Project Name:	Renovation of Chris Gibson Recreation Centre Drive	Project No.	T2023-125
		DATE:

Request For Information 23-214-023

Subject: **REF-10 – Sequence of Operations**

Ref: Chris Gibson IFC M-801,
Chris Gibson IFC_s Refrigeration drawing.pdf , sheet 4
Comments on SD-144R1 DSA page 53 of 59

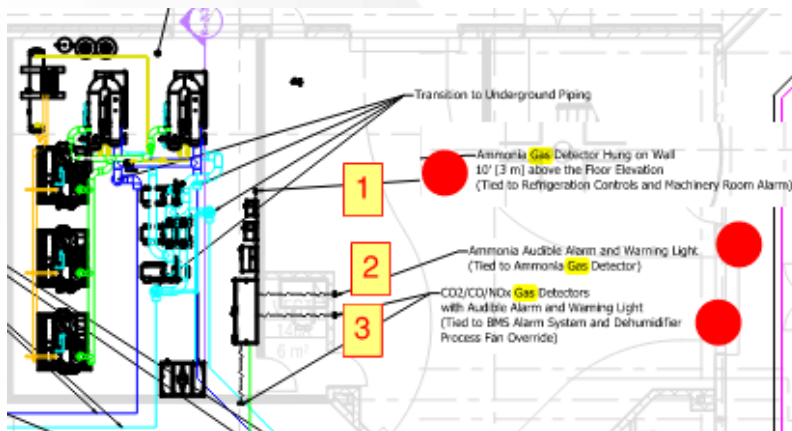
2. IFC mechanical drawing M-801 – Notes 20, 21:
 - Note 20: “Provide high level and low level inlets complete with bird screen and motorized damper at ductwork below fan, to be coordinated on site with location of refrigerant leak.”

- Note 21: “Fan to be interlocked to refrigerant detection panel. Fan to run at high speed at all times with upper inlet under normal operation. On refrigerant leak detection, upper inlet to close, lower inlet to open, and fan to switch to low speed.”

ACCENT: I think the inlet damper conditions here are correct, but we should probably run at high speed if an ammonia leak is detected. I think the simplest method to provide the ventilation rates required by code would be to run the ventilation fan at low speed all the time (25% speed) and then ramp up to 100% speed if ammonia is detected or if the plant room gets more than 10°C above the outdoor ambient temperature. The outdoor ambient temperature can be read to the BAS through the dehumidifier sensors via BACnet. The BAS would close a relay on the VFD digital inputs to go to high speed in the event the temperature threshold is exceeded.

Ice Rink
Refrigeration
System Plan
View

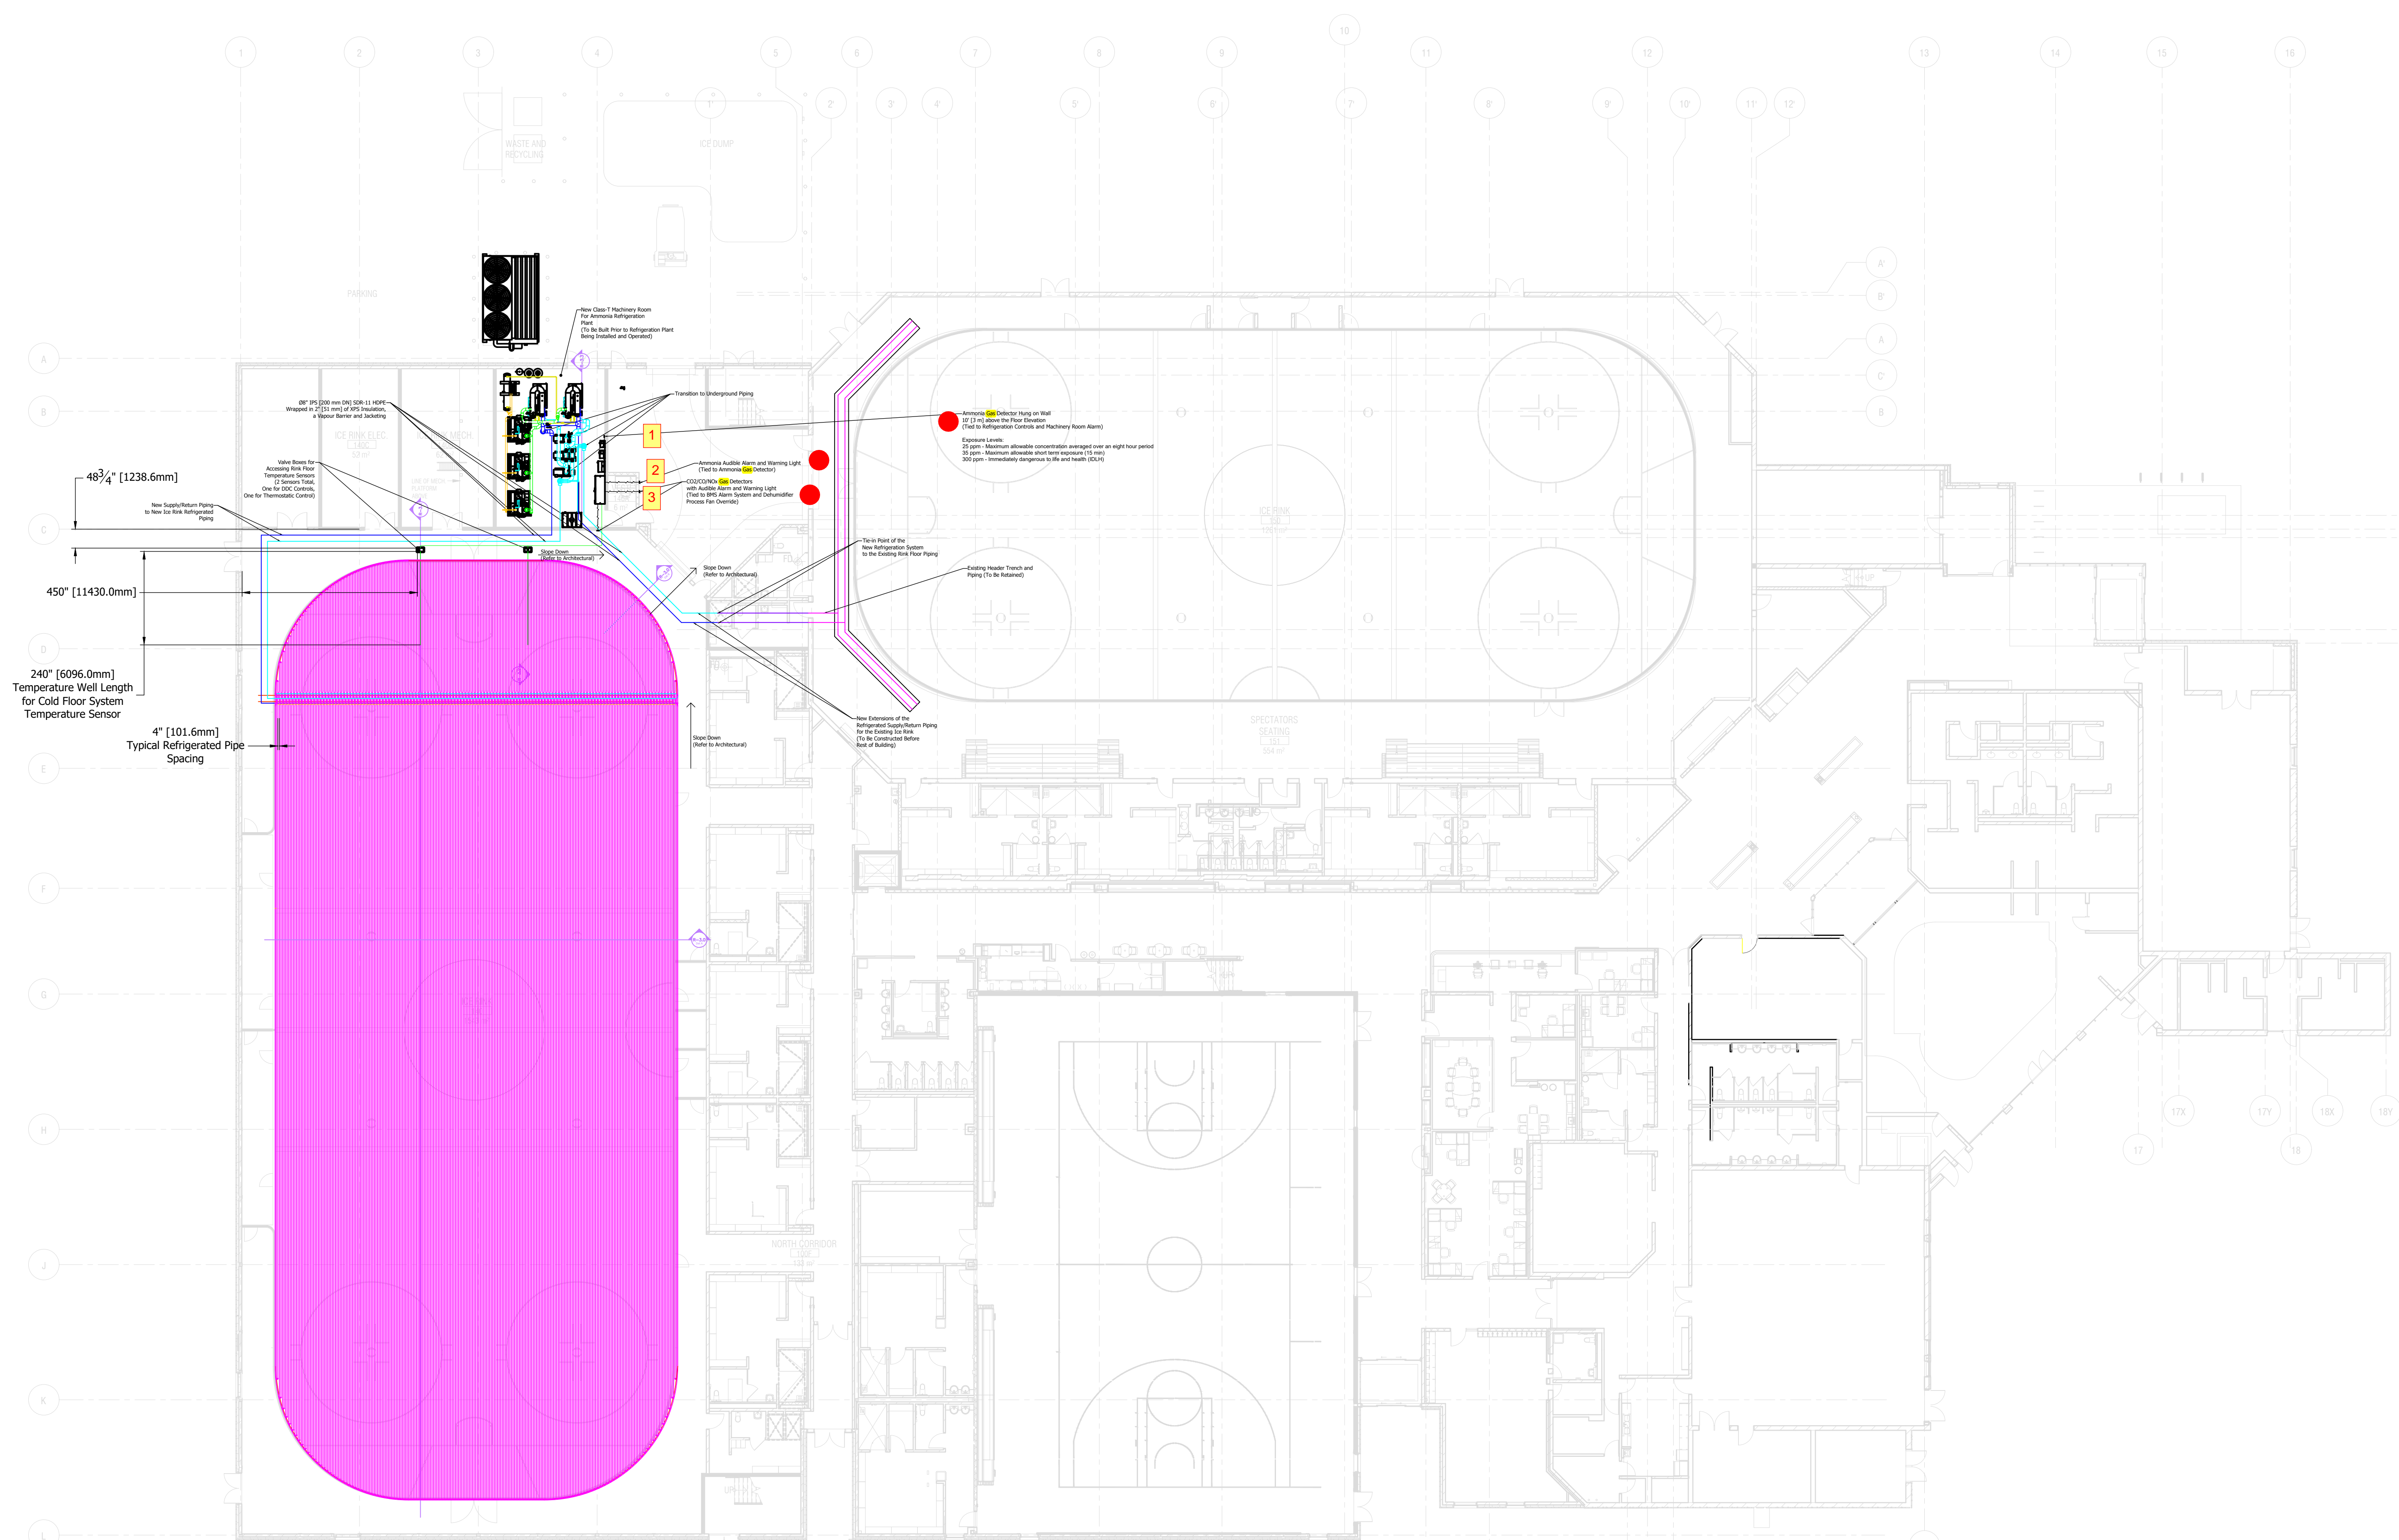
3. Chris Gibson IFC_s Refrigeration drawing.pdf – sheet 4,
Based on our review, the following components are not within our scope of work. BAS responsibilities are limited to monitoring the related gas alarms via BACnet MS/TP/IP or hardwired connections. Additionally, Ainsworth has not received any datasheets for these devices despite several inquiries:

- 1 - Ammonia Gas Detector Hung on Wall 10' [3 m] above the Floor Elevation (Tied to Refrigeration Controls and Machinery Room Alarm)
 - 2 - Ammonia Audible Alarm and Warning Light (Tied to Ammonia Gas Detector)

- 3 - CO2/CO/NOx Gas Detectors with Audible Alarm and Warning Light (Tied to BMS Alarm System and Dehumidifier Process Fan Override)

ACCENT: That is correct. The ammonia gas detector, ammonia alarms/warning lights and the IAQ detectors in the ice arena (for the dehumidifier) are not within Ainsworth's scope of work.

The ammonia items are in CIMCO's scope of work because they are supplying and installing the ammonia detection system. The IAQ sensors in the ice arena would be in Consult Mechanical's scope because they are supplying and installing the dehumidifier

REF-01 & REF-02

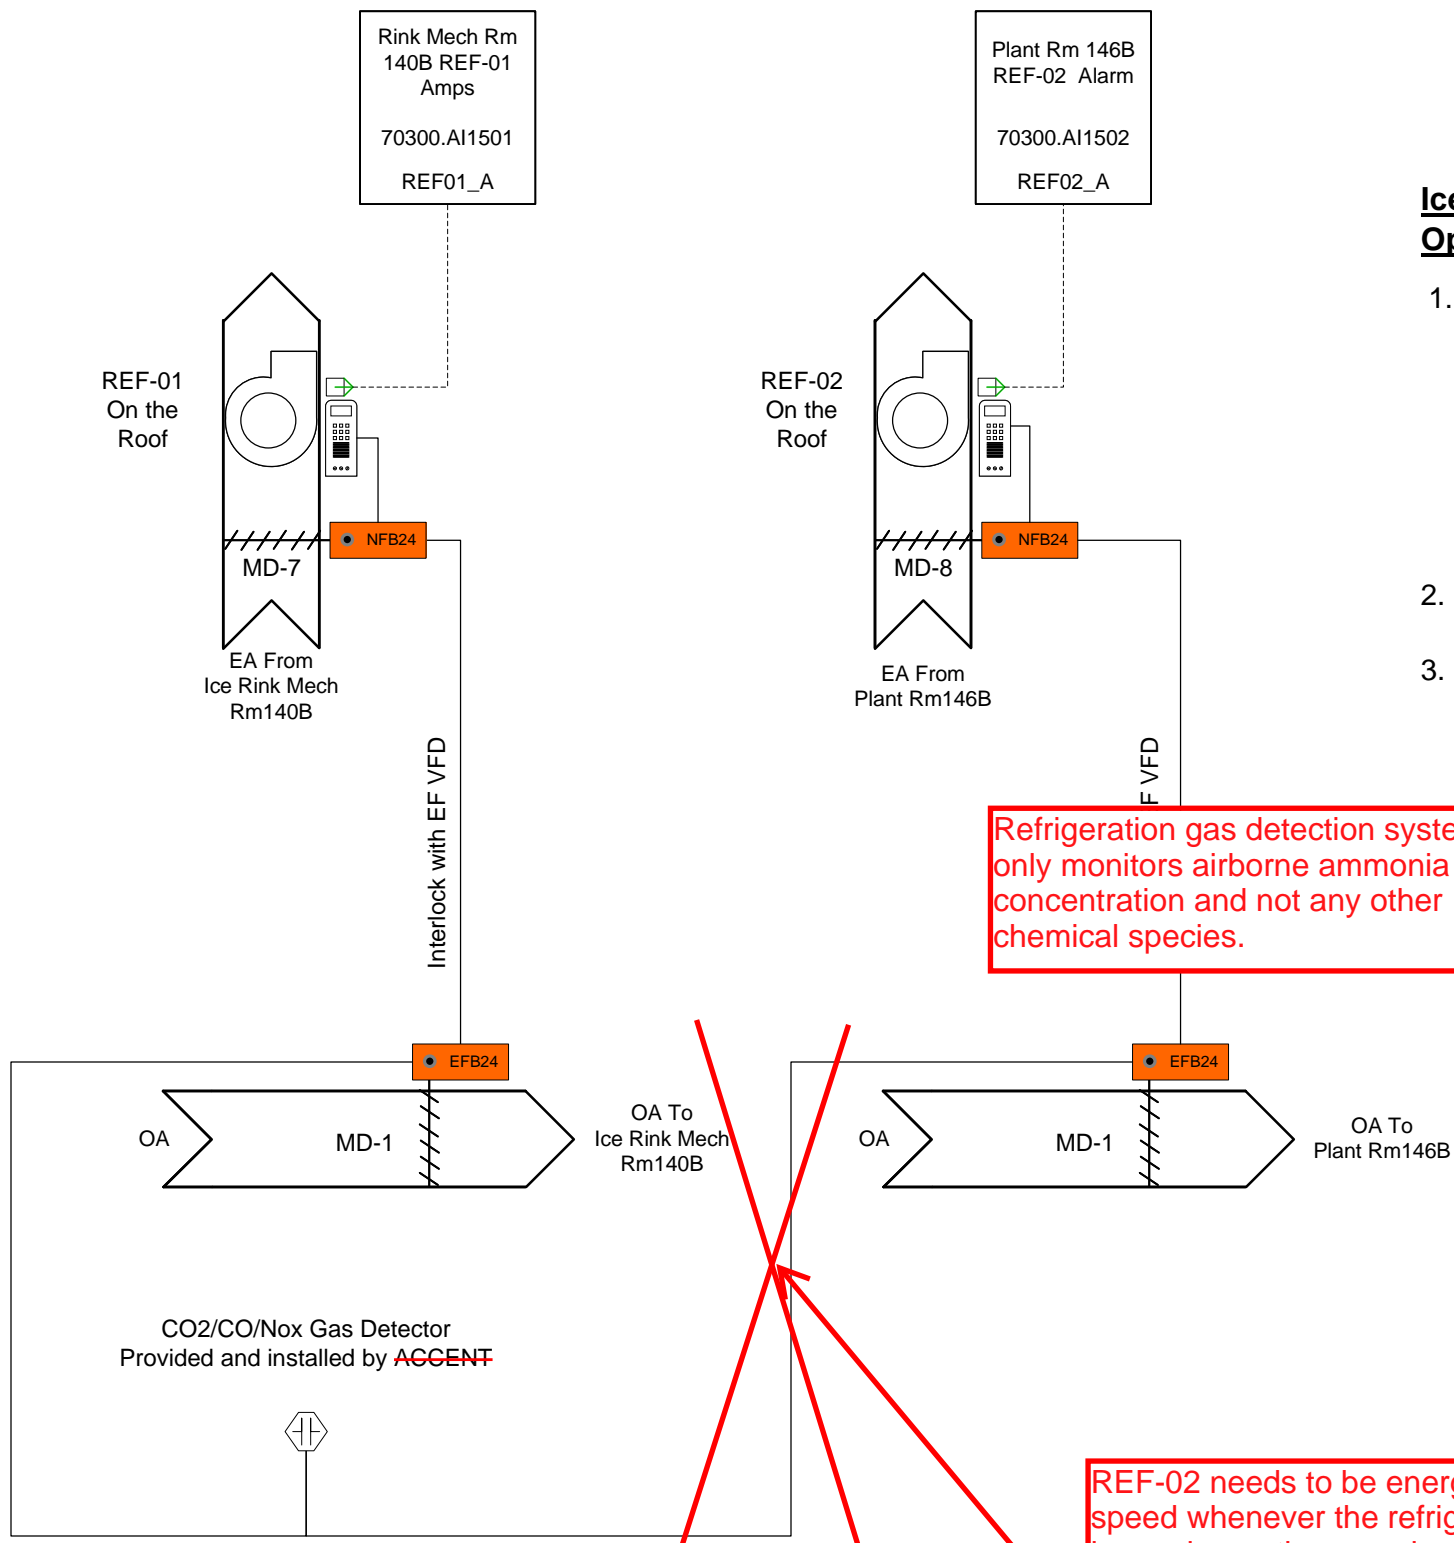
4. SD-144R1 DSA - page 53 of 59:

- Drawing is attached.
- Reviewed comments from Logan Bakker as below,

- Refrigeration gas detection system only monitors airborne ammonia concentration and not any other chemical species.
- Only REF-02 in the Plant room (146B) will have an interlock with the refrigeration gas detection system.

ACCENT:
Correct.

Refrigeration gas detection system only monitors airborne ammonia concentration and not any other chemical species.

Only REF-02 in the Plant room (146B) will have an interlock with the refrigeration gas detection system.

REF-02 needs to be energized at low speed whenever the refrigeration plant is running or the room is occupied (not by IAQ conditions). It is run at full speed whenever the airborne ammonia concentration exceeds 25 ppm.
